Lodged Electronically: www.aemc.gov.au Reference EPR0039

OPTIONAL FIRM ACCESS – PROTOTYPE PRICING MODEL

OPTIONAL FIRM ACCESS – PROTOTYPE PRICING MODEL - OBSERVATIONS

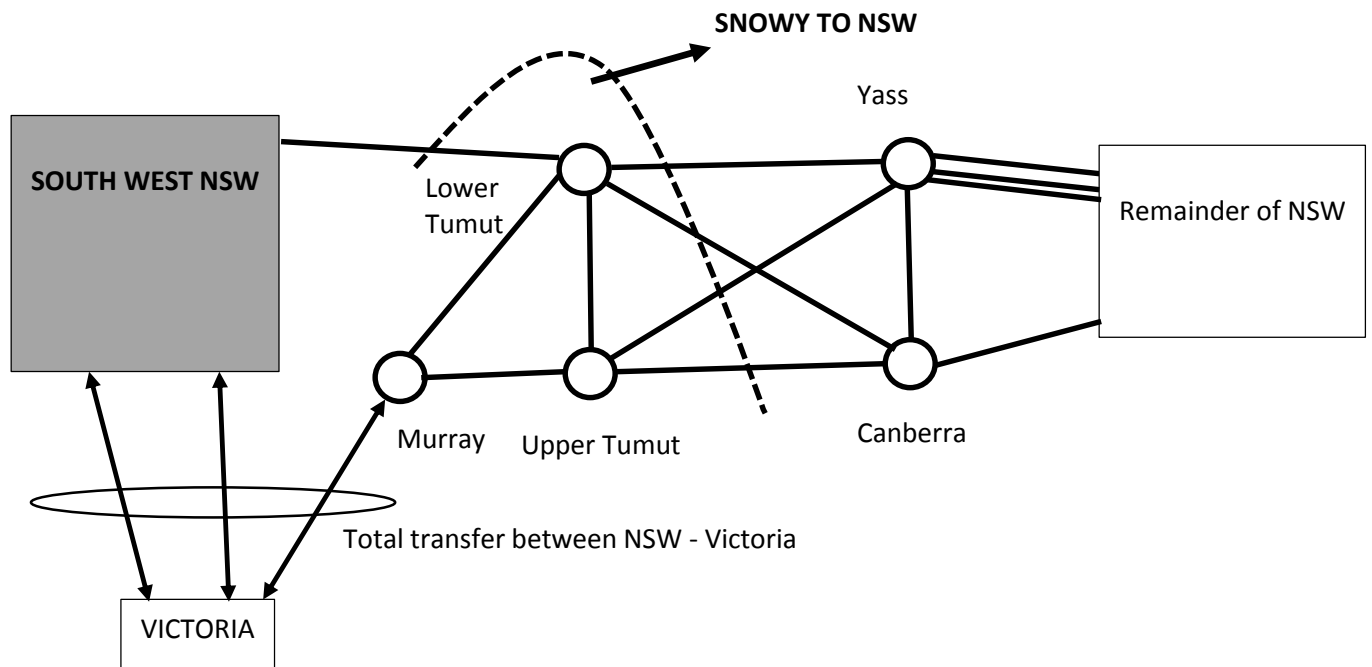
The Snowy power stations together with power flow over the interconnections with Victoria supply south west NSW, with the remainder flowing on to the NSW system at Yass and Canberra, as shown below. The flow “Snowy to NSW” in the figure significantly loads the lines between the Snowy power stations and Yass / Canberra and further loads the lines between Yass / Canberra and the remainder of the NSW system. In the past the ratings of the Snowy to Yass / Canberra lines have constrained power flow from Snowy at times of peak load.

The pricing model results show the Snowy to NSW power flow (for the case study of Section 1) for 2014:

Hence the pricing model dispatch pattern does not load the southern system to the levels experienced at times of peak load.

CASE 1: YASS - GUNNING – GOULBURN – MARULAN 132kV NETWORK

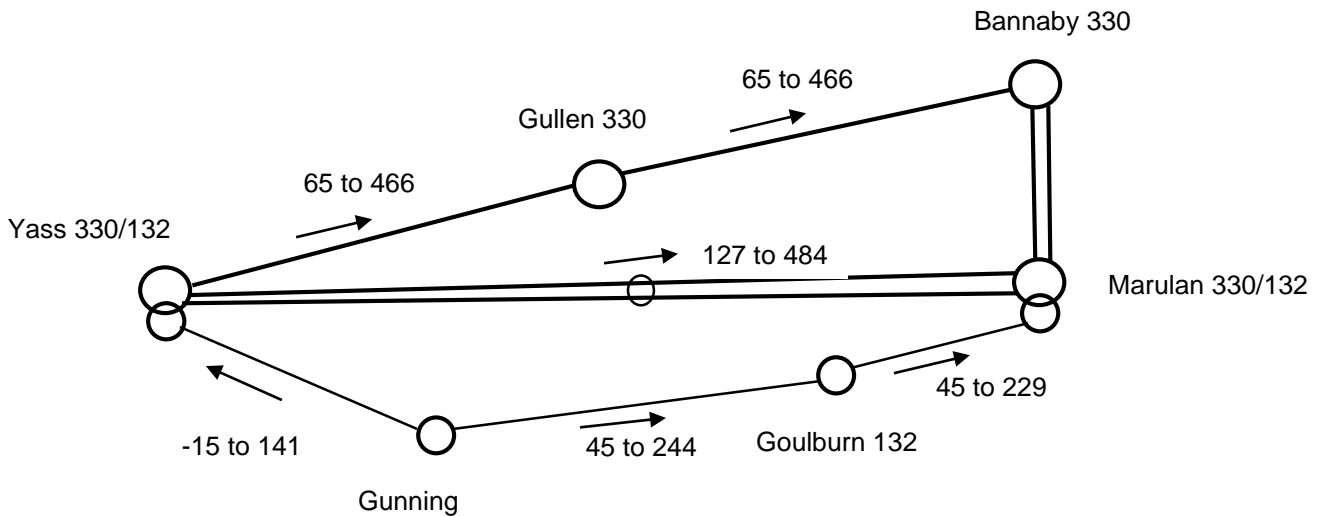
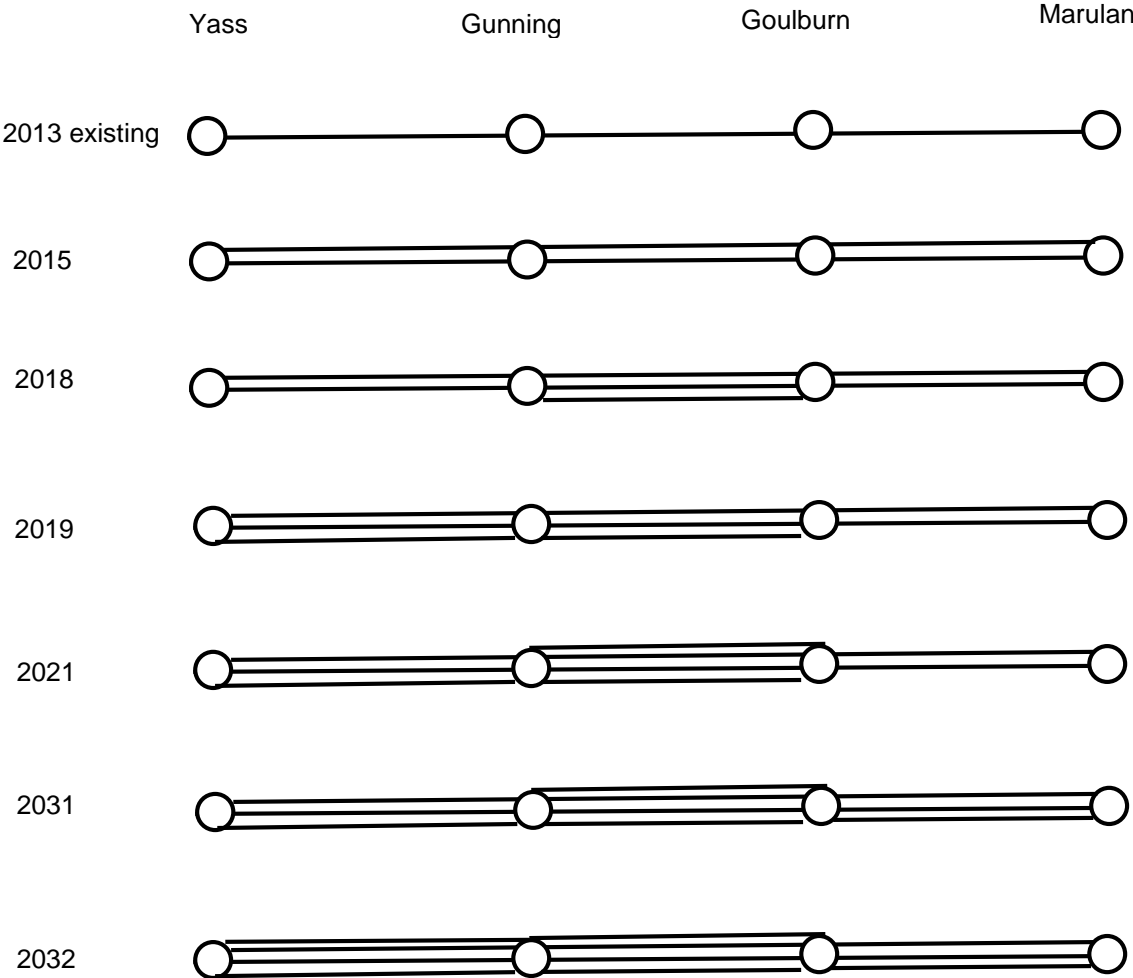
In the absence of any generation at Gullen Range, the pricing model produces the base power flow as shown below. The power flows are for 2013 and 2030.

It is clear that there is insufficient 132kV line capability, both under normal system conditions and following the outage of a parallel 330kV line.

The pricing model determined the following 132kV augmentations:

Hence over about 16 years the model has added 8 new circuits. Part of the reason for this number of circuits was the selection of relatively low-rated line augmentations that then overloaded in subsequent years.

The construction of 8 new circuits in this system is probably not feasible. There would be environmental issues and access to the substations may be an impediment.

A transmission planner might develop other options such as those below. These options have not been fully tested but provide an indication of what may be possible.

If firm supply is not required for Goulburn, it may be possible to augment the network with two new 132kV circuits connecting Gunning and Yass (probably replacing the existing low rated line) together with opening of the Gunning – Goulburn line.

Planning Option 1

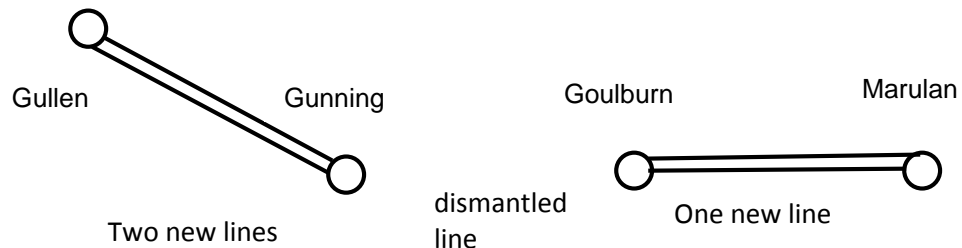
The purpose of opening the 132kV line is to remove the impact of high power flows following the outage of a parallel 330kV line. The open line would operate on a change-over scheme such that on outage of the Marulan – Goulburn line the normally open circuit would be closed with Goulburn then supplied from Gunning. The changeover could be automatic. The new lines could be two single circuit lines or a double circuit line.

One of the new Gunning – Yass lines may be able to be avoided if the Gunning WF does not require firm supply, ie. can tolerate brief unplanned outages of the line.

CASE 2 – BANNABY – SYDNEY LINE DEVELOPMENT

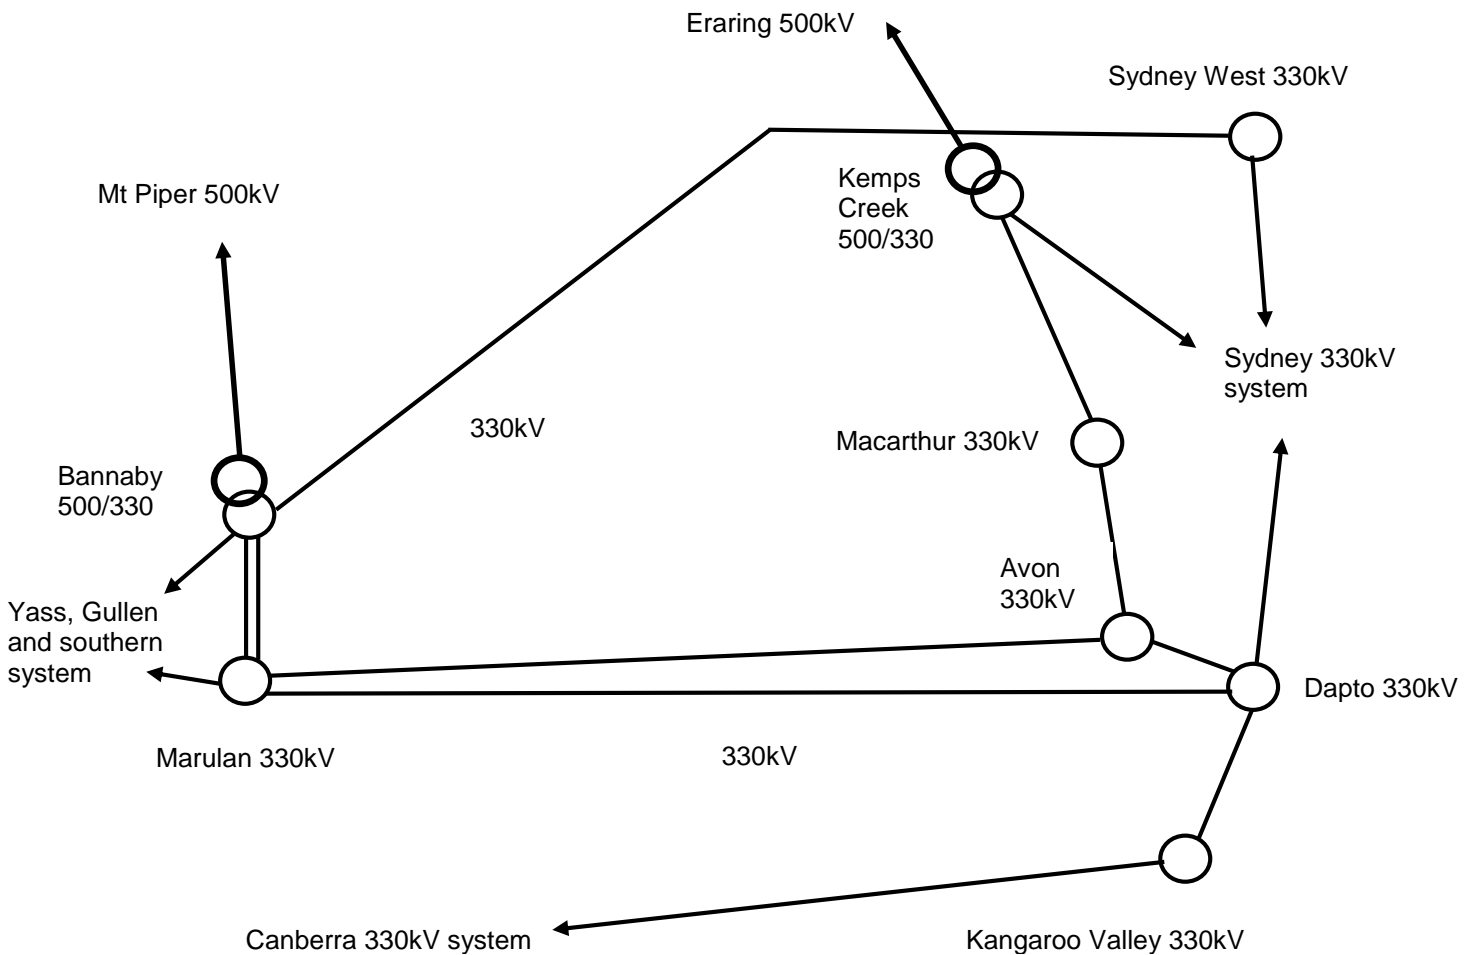
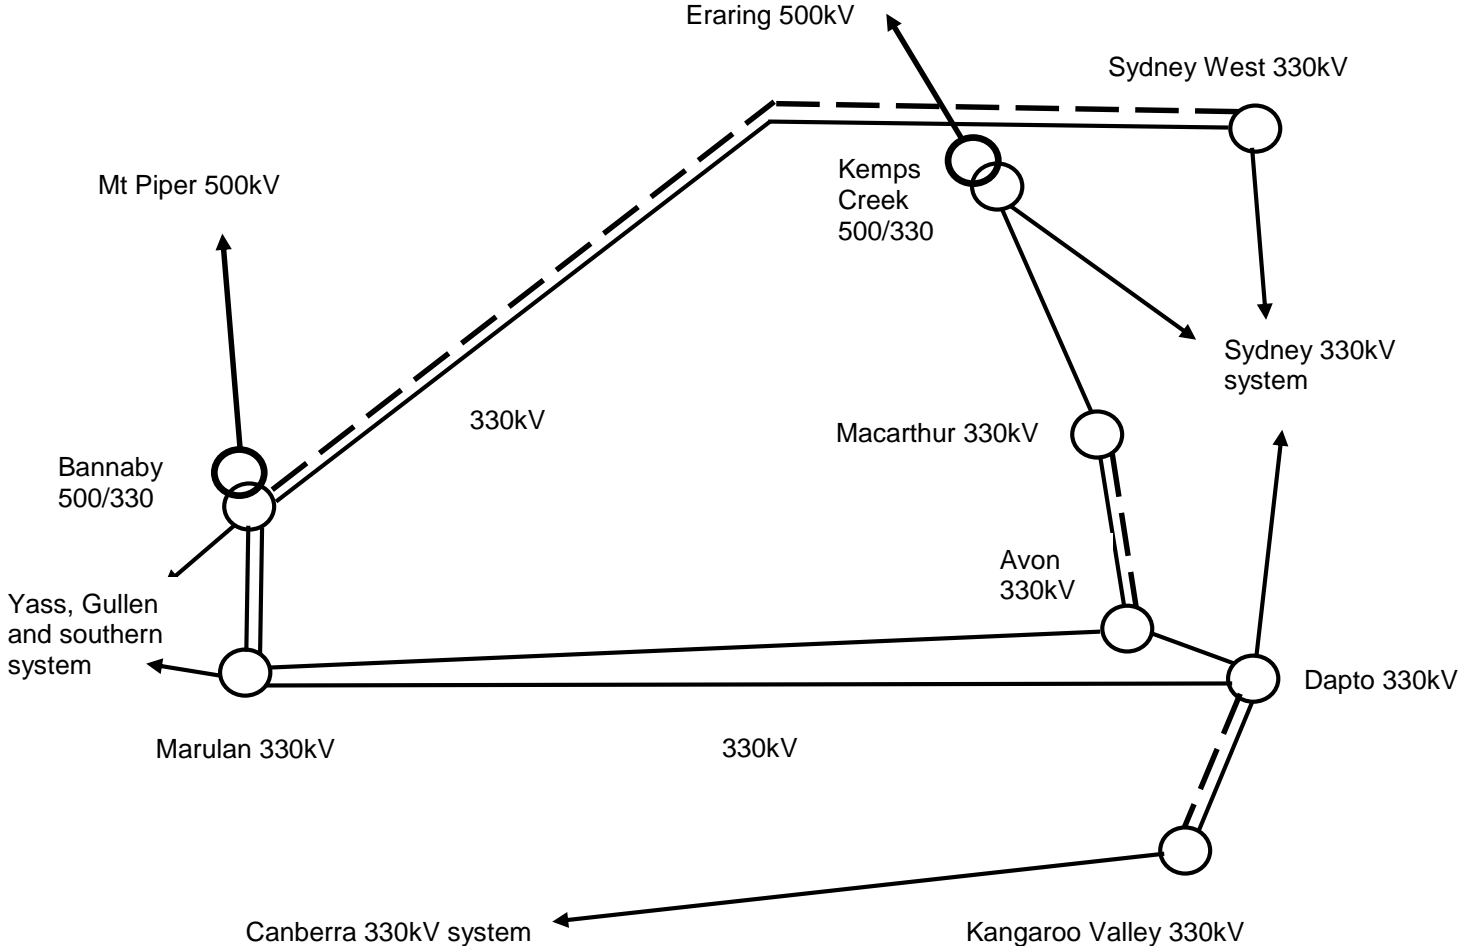
The existing 330kV network in the area north of Bannaby is shown below. With high generation in the south and a 1000MW generator at Yass it would be expected that the network between Bananby and Sydney, and / or between Kangaroo Valley / Dapto and Sydney would need augmentation.

The pricing model indicates the following 330kV augmentations to this system, as shown below.

TransGrid has a long term strategy for addressing constraints between the Bannaby area and the Sydney area by rebuilding the Bannaby – Sydney West 330kV line as a 500kV double circuit line, largely on the existing easement¹¹. It would be terminated at Bannaby and a 500kV terminal in Sydney. A 500kV double circuit line on the existing easement is preferred due to constraints on the ability to build new lines into the greater Sydney area.

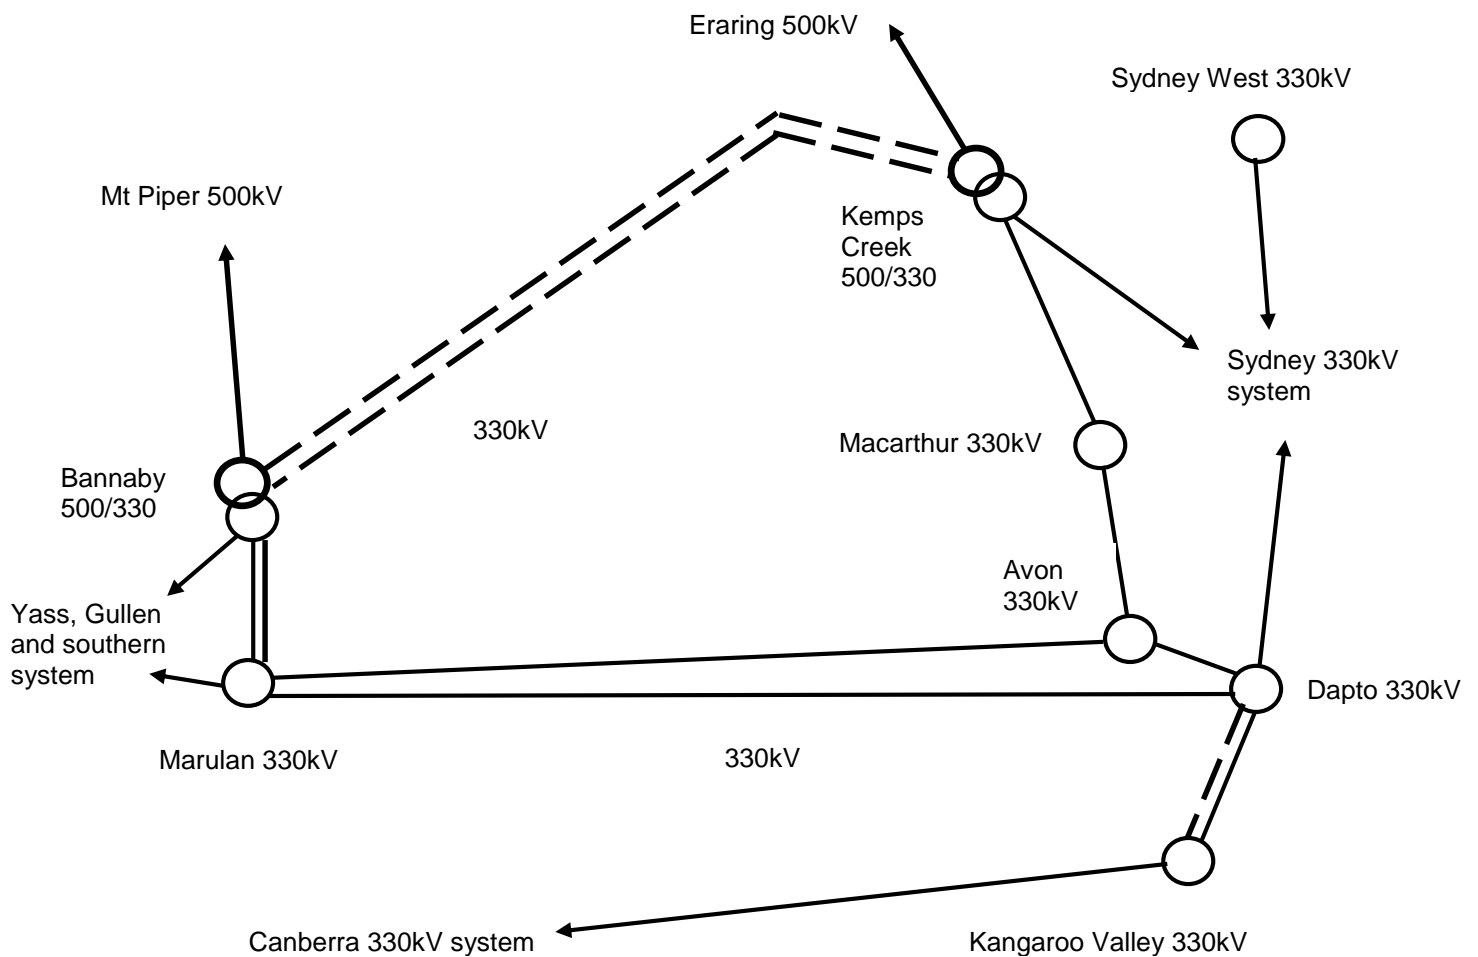
If this network development is adopted instead of the pricing model option the outcome is shown below¹². The 500kV line has been terminated at Kemps Creek but other options for termination in the Sydney area are possible.

It may also be possible to defer the cost of the 500kV terminations for the new line by initially operating it at 330kV. Fault level constraints in Sydney may need to be resolved in this case. The following is the set of augmentations:

Network development	LRIC
Pricing model developments	\$89.9M or \$89.9/kW
New 500kV double circuit line	\$124M or \$124/kW
500kV double circuit line operates at 330kV	\$99M or \$99/kW

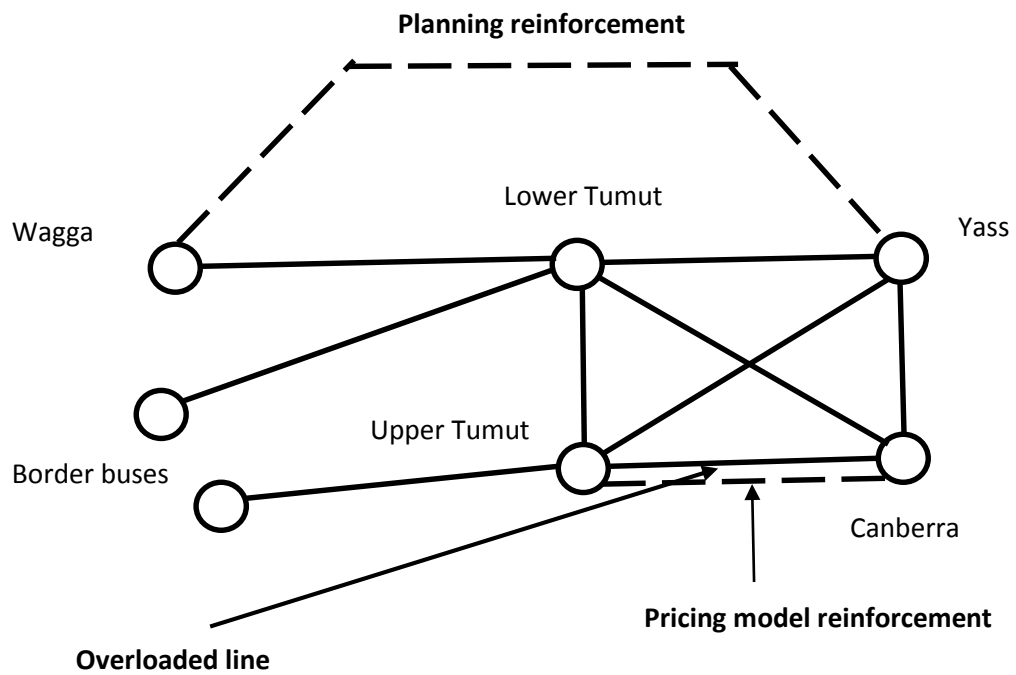
The pricing model identifies an overload of the Upper Tumut – Canberra line and adds a duplicate line with a contribution of \$33.7M to the LRIC.

The construction of a new line through the national park in the area is not feasible. An alternative is the construction of a 330kV line from Wagga to Yass, with associated power flow control. The total LRIC would be much higher as a result.

The pricing model augmentation and the possible planning alternative are shown in the figure below.

In such cases as this it may be possible to arrange for a set of feasible reinforcement options to be developed with appropriate costs. The pricing model may be able to be modified to select from the set of feasible options, rather than duplicating the line.

NSW – Victoria

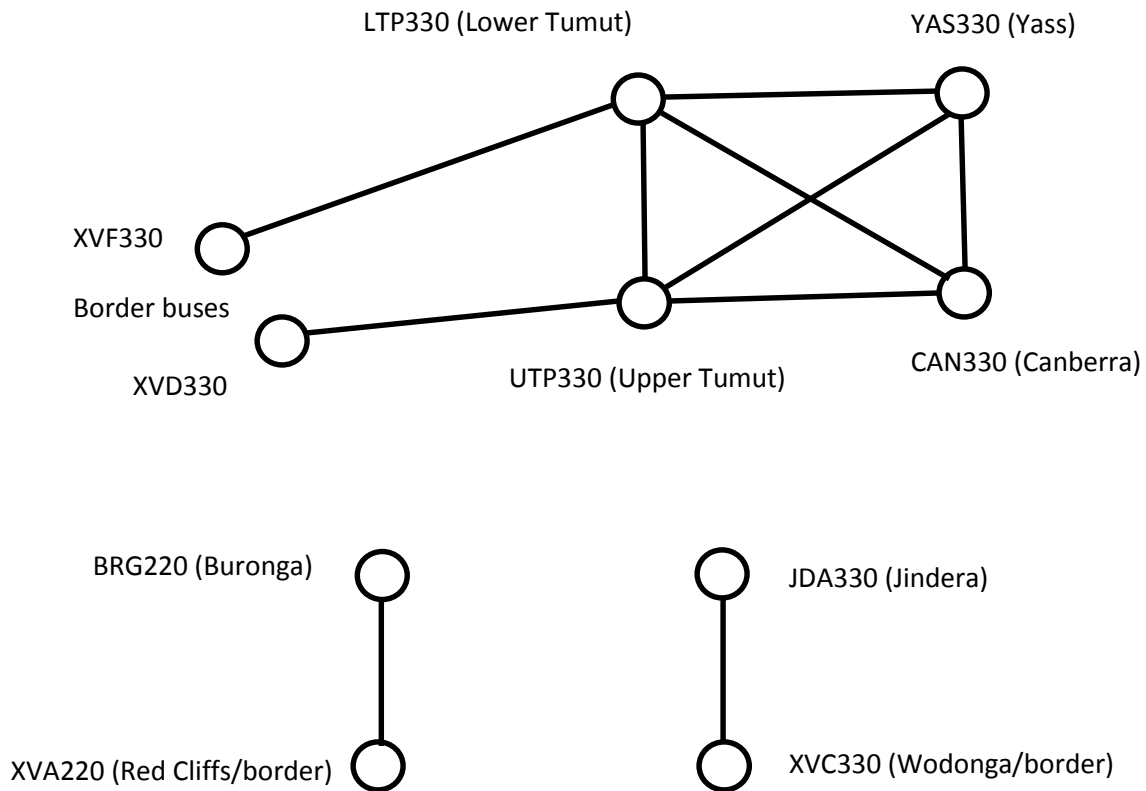
The NSW – Victoria 330kV interconnections, via the Snowy system and Jindera, and the western 220kV interconnection are shown below:

Ideally the Murray bus (connected to Upper Tumut and Lower Tumut) and the connections between Murray – Dederang and Wodonga, and connections in the Victorian 220kV network may need to be represented.

The Snowy – Victoria connections may be important in reasonably representing the impact of additional generation in the Snowy – Wagga area.
